STAFF RECOMMENDATION
811 Boscobel Street
May 15, 2013

Application: New construction - addition
District: Edgefield Historic Preservation Zoning Overlay
Council District: 06
Map and Parcel Number: 08216029500
Applicant: Ann Nielson
Project Lead: Robin Zeigler, Robin.Zeigler@nashville.gov

NIELSON PORCH
811 BOSCOBEL ST
NASHVILLE TN

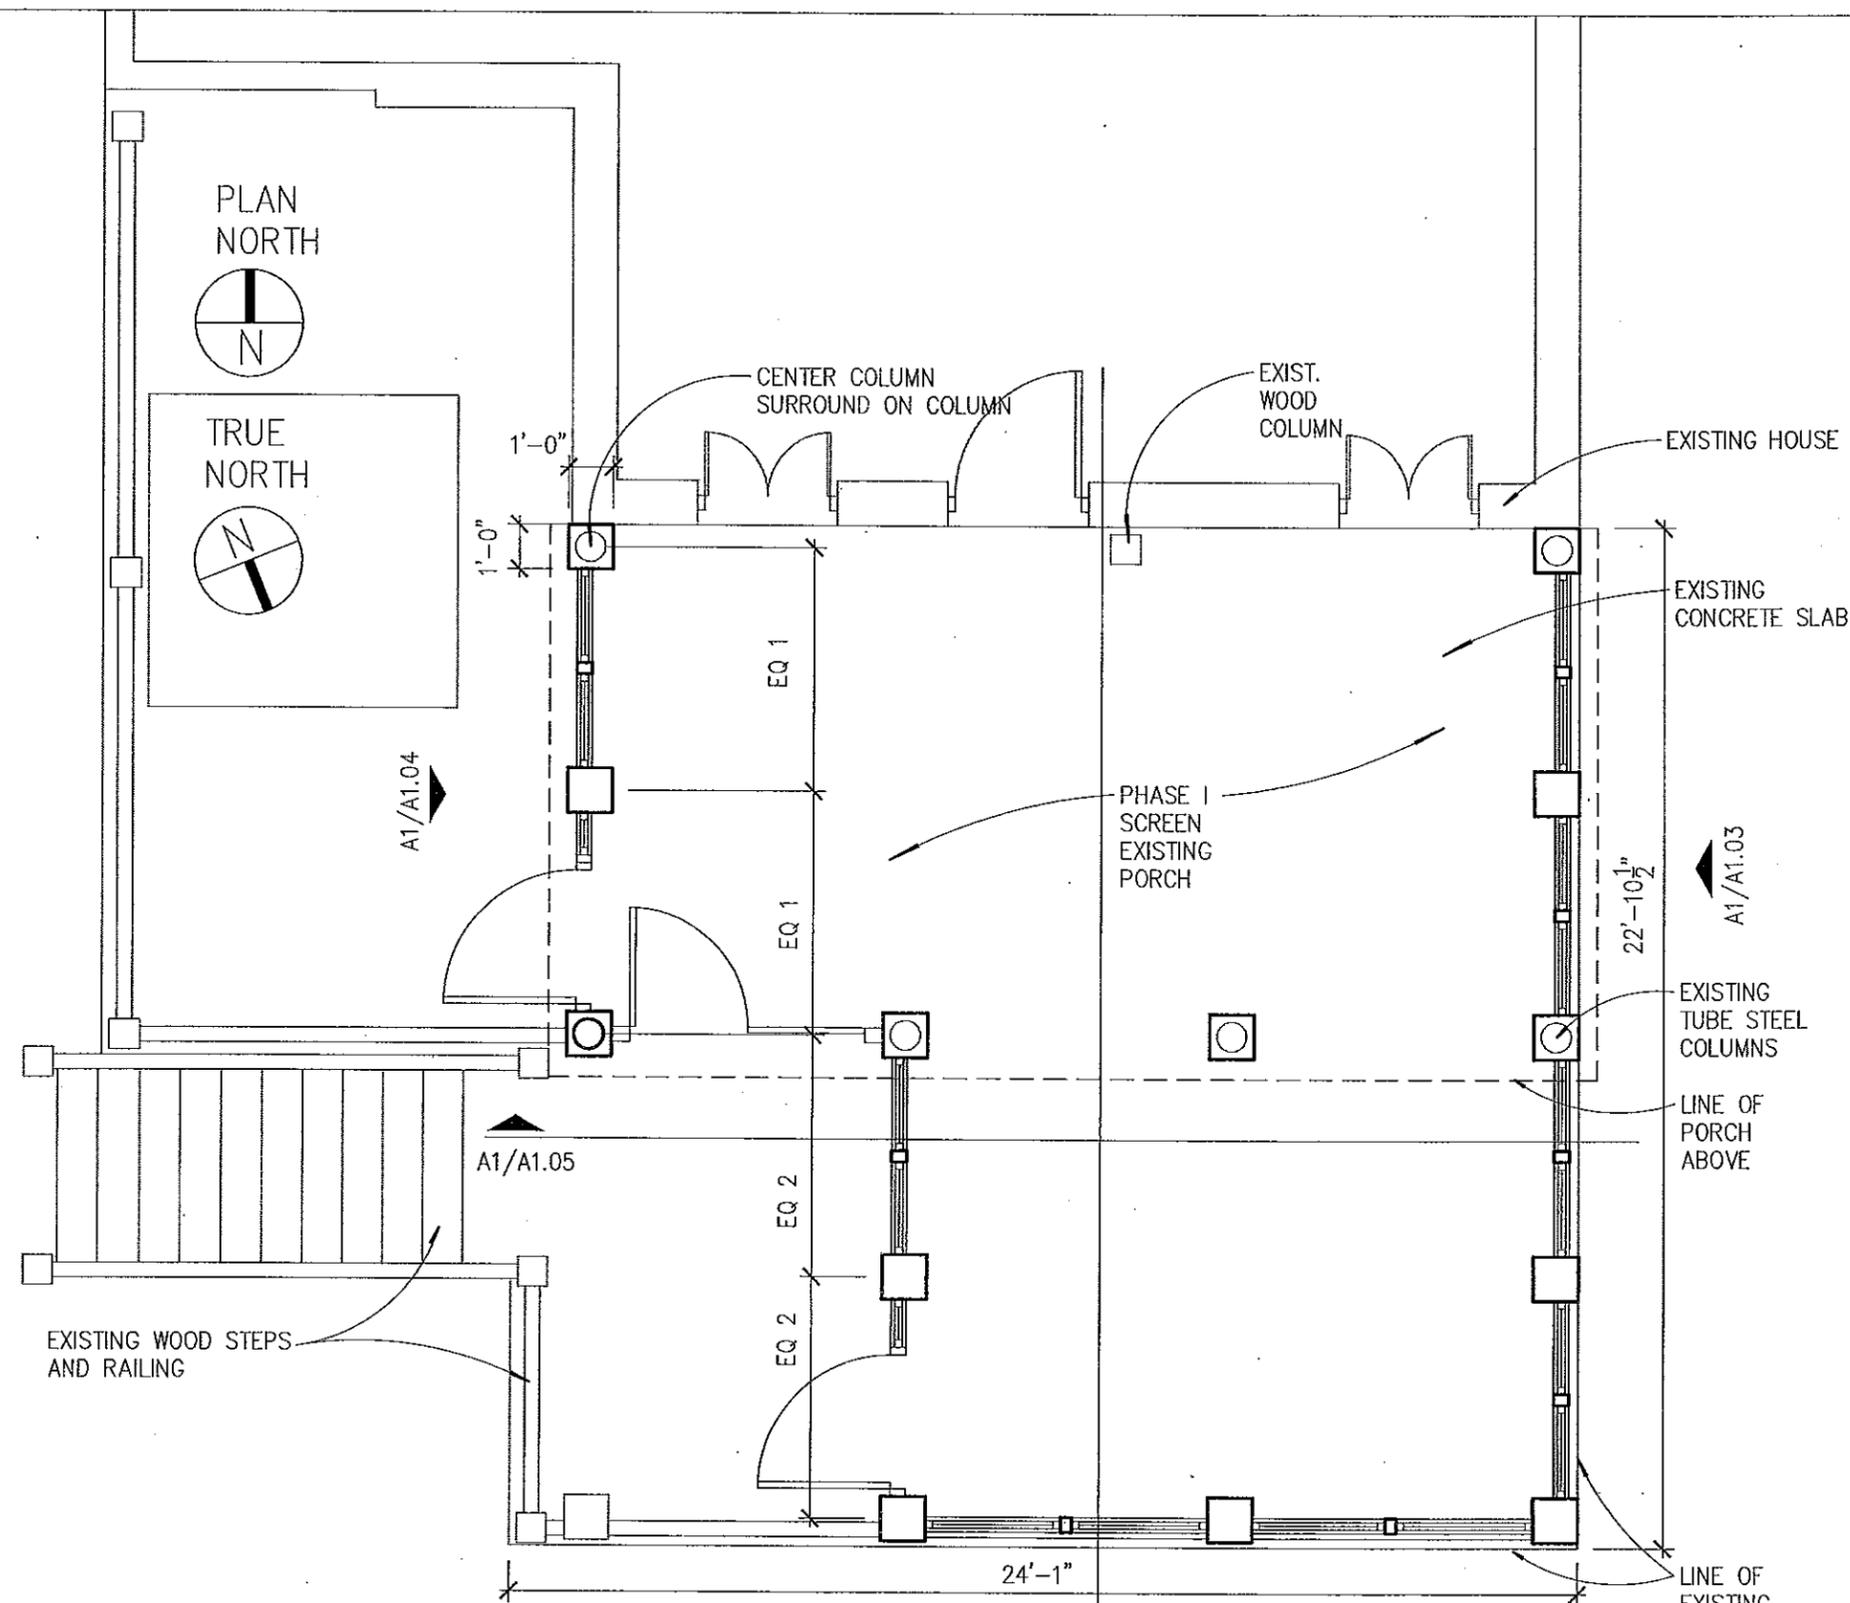
Enclosure of Porch: An existing two-story porch with parking space at the basement level already exists. The first floor is partially covered by the second-story porch floor. The applicant proposes adding a shed roof to the uncovered portion, and screening in the entire porch. Screening porches is appropriate if they are at the rear of the building, as this one is. The project meets section II.B. 2.

A1 REAR ELEVATION
 1/4" = 1'-0"

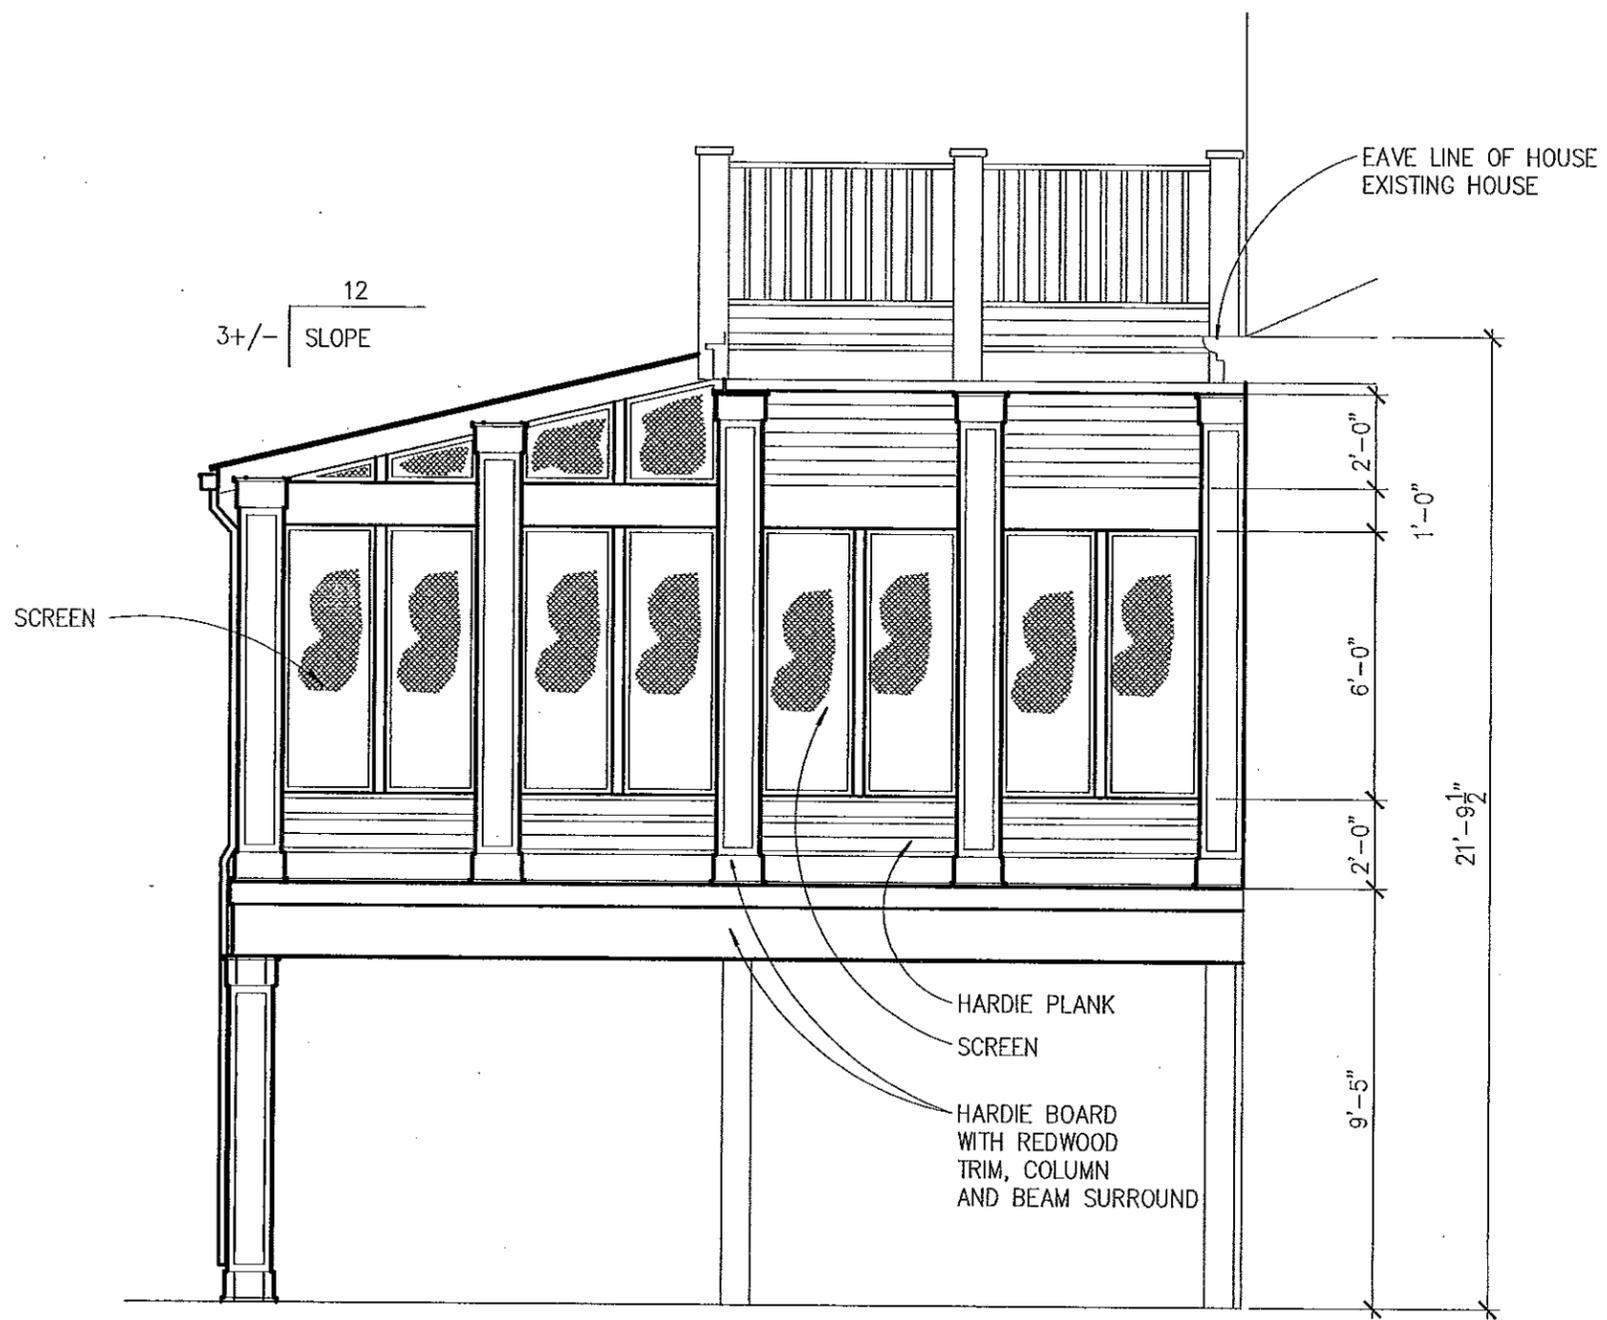
Materials: The porch posts shall be redwood and the partial cladding shall be cement fiber lap siding. Staff recommends that the lap siding have a smooth finish and have no more than a five inch (5") reveal. The new roof shall be standing seam metal and the

color is not indicated. Staff recommends Staff review of the final color. With the condition that the metal roof color be approved by Staff and that the lap siding have a smooth finish with a maximum reveal of five inches (5”), the project meets section II.B.5.

Staff recommends approval with the conditions that Staff review the color for the roofing and the lap siding have a smooth finish and no more than a five (5”) reveal.
